# **UNIVERSITY OF MISSOURI RESEARCH REACTOR**

## **REACTOR OPERATIONS ANNUAL REPORT**

**1 January 1996 - 31 December 1996**

1995 Revision to Original HSR, Figure 3.1:

Figure 9.6

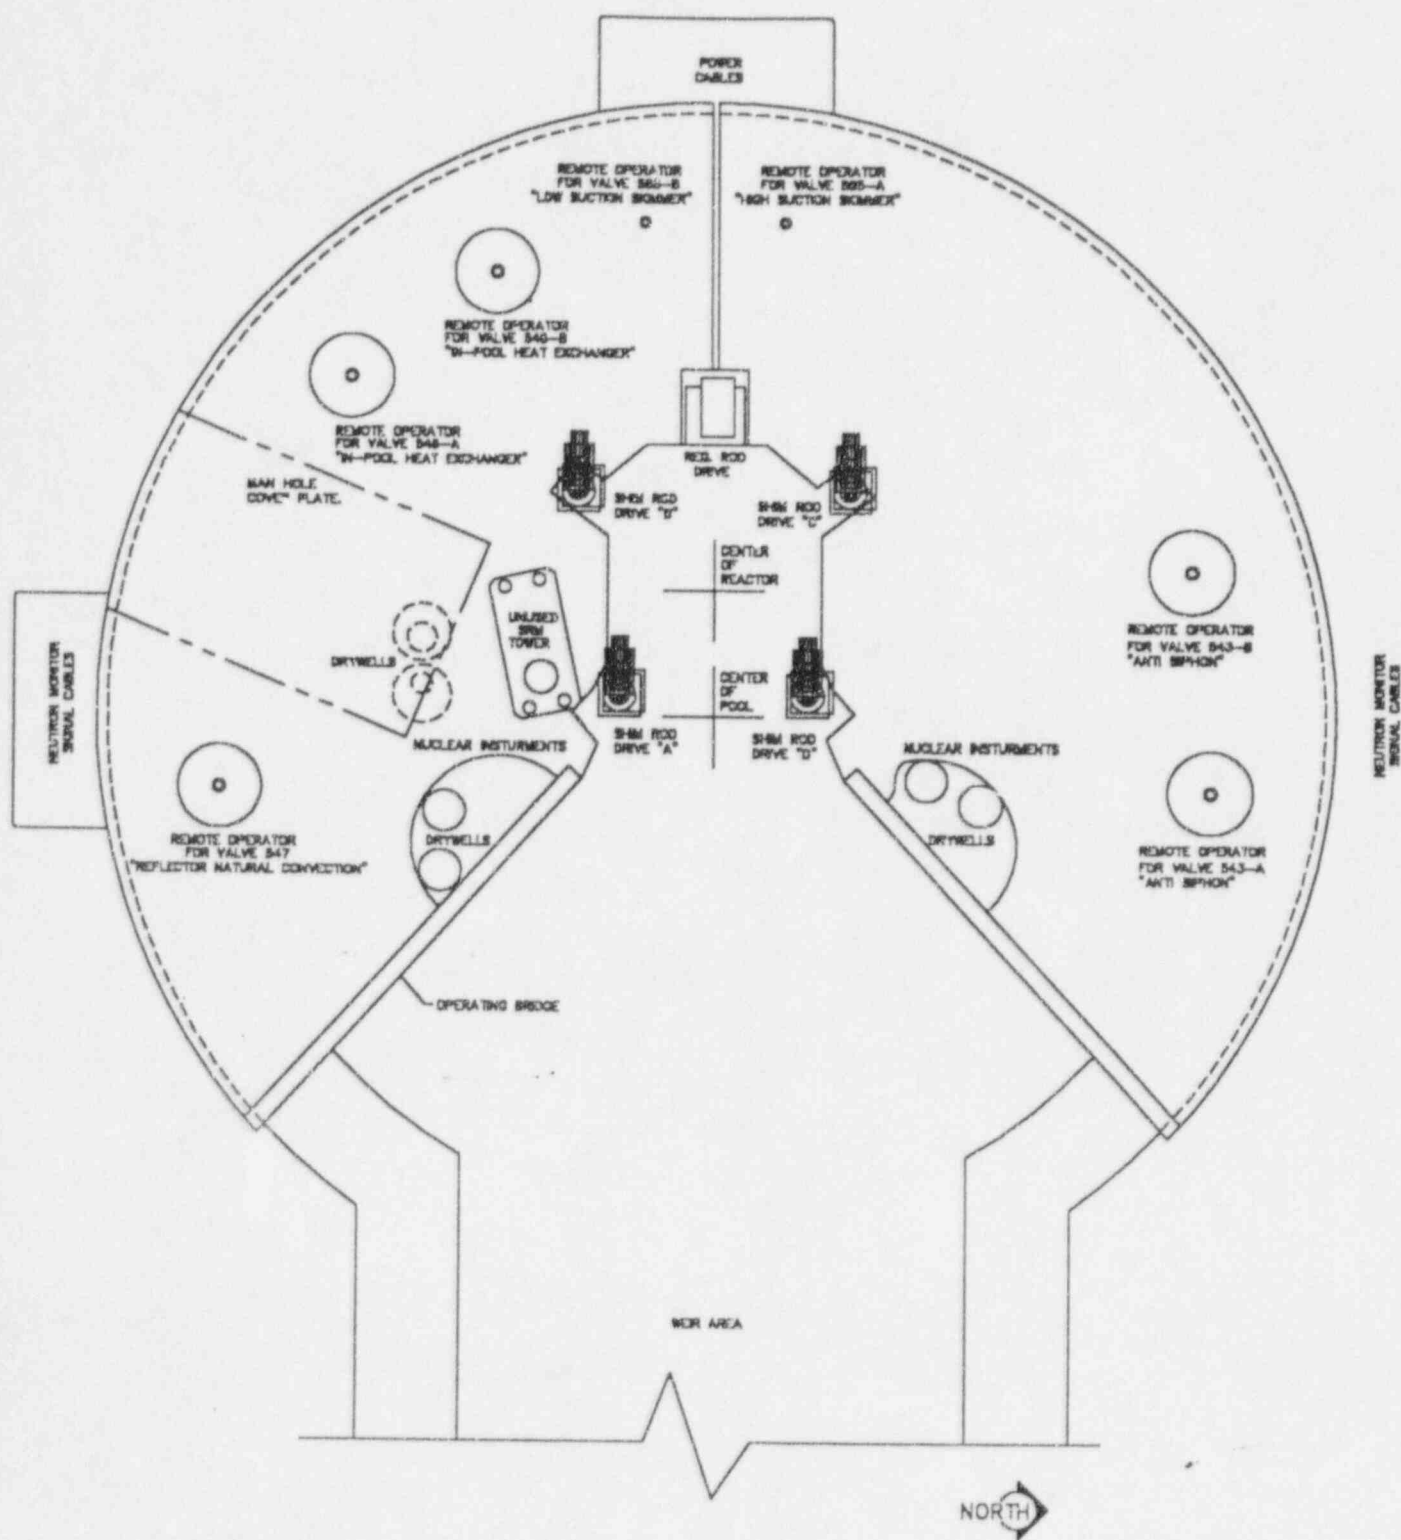
**Original HSR, Figure 9.6:**

Replace with: Updated Figure 9.6--Operating Bridge Plan View (dated 2/7/97)

FIGURE 10.1

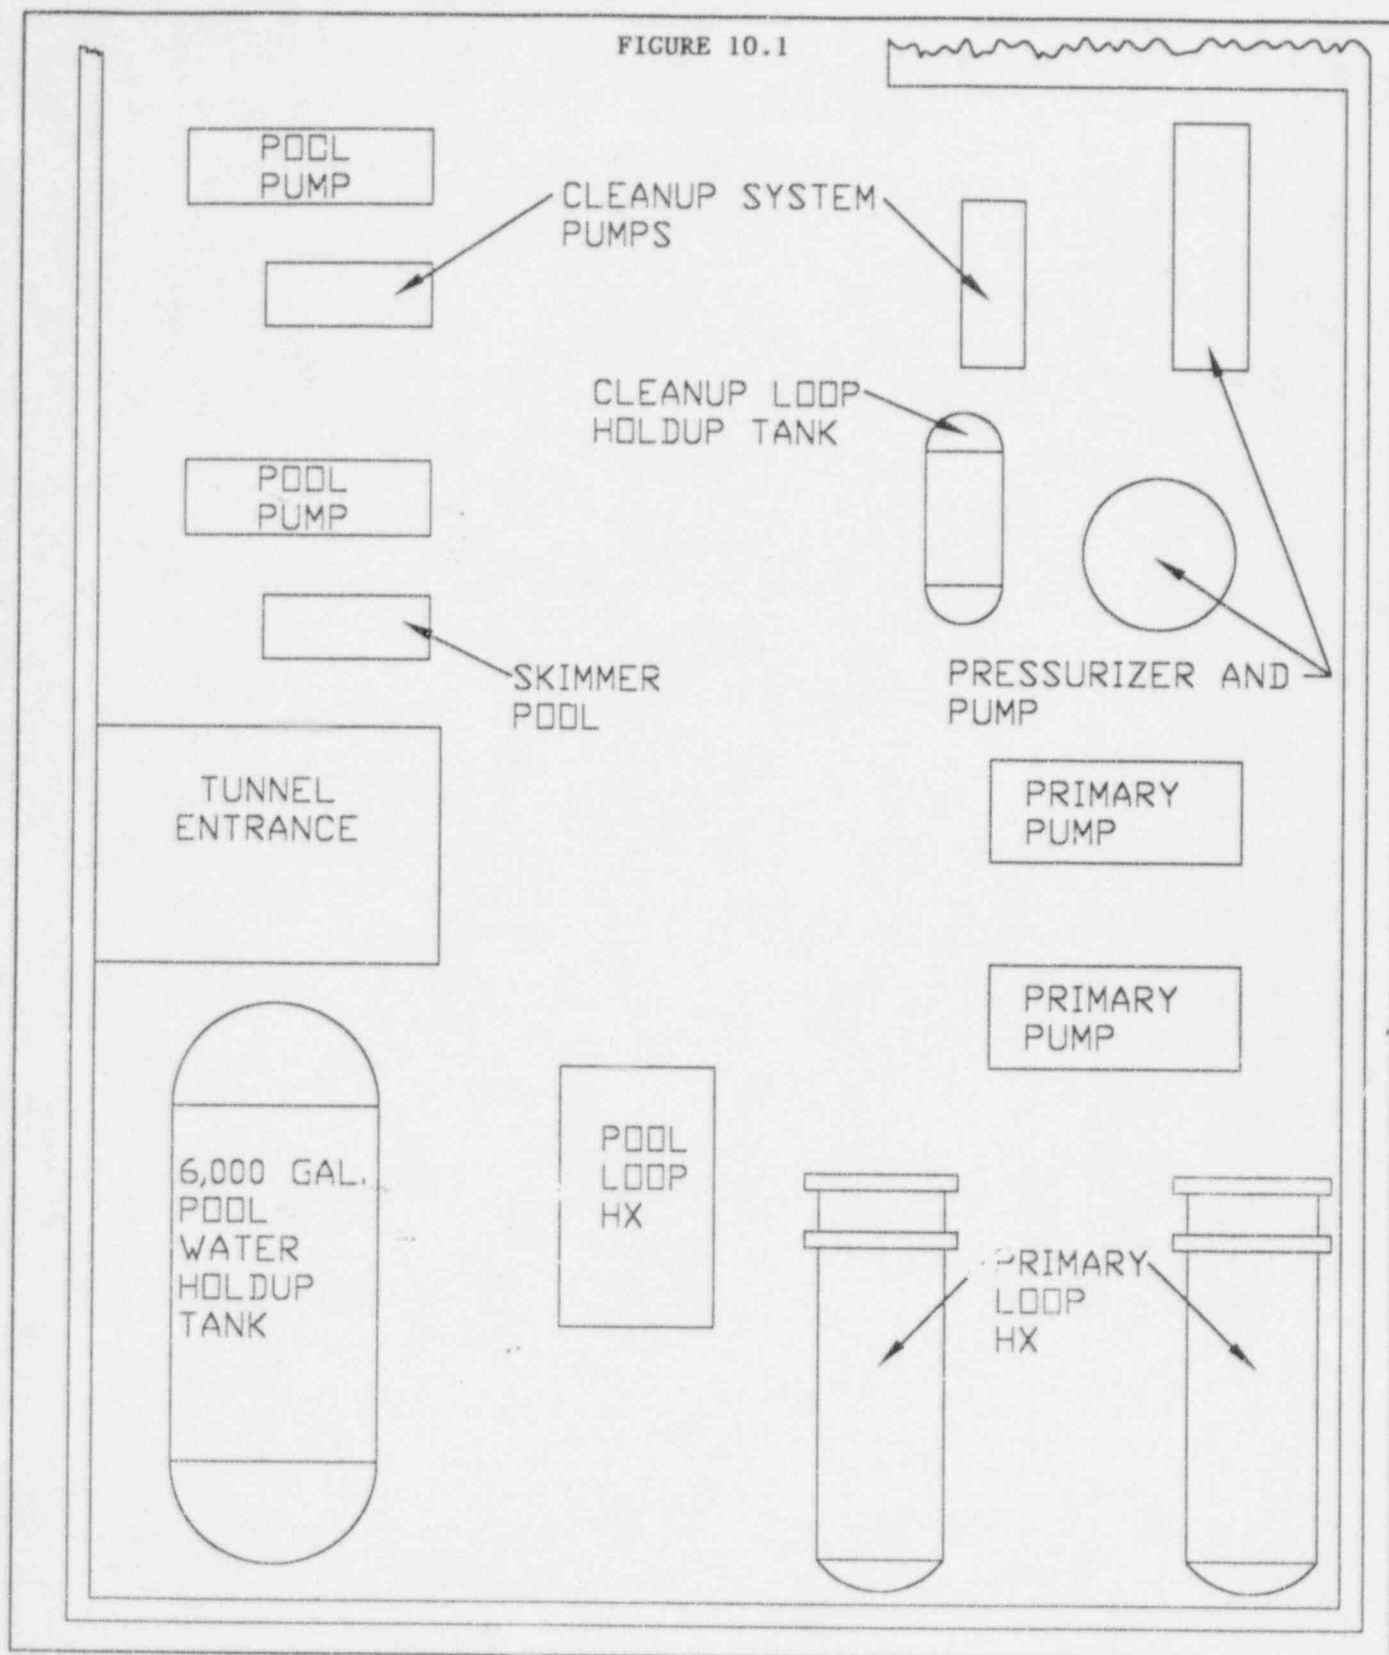
**Original HSR, Figure 10.1:**

Replace with: Updated Figure 10.1--Main Reactor Equipment Room (MURR Dwg #2463, Rev. 0)
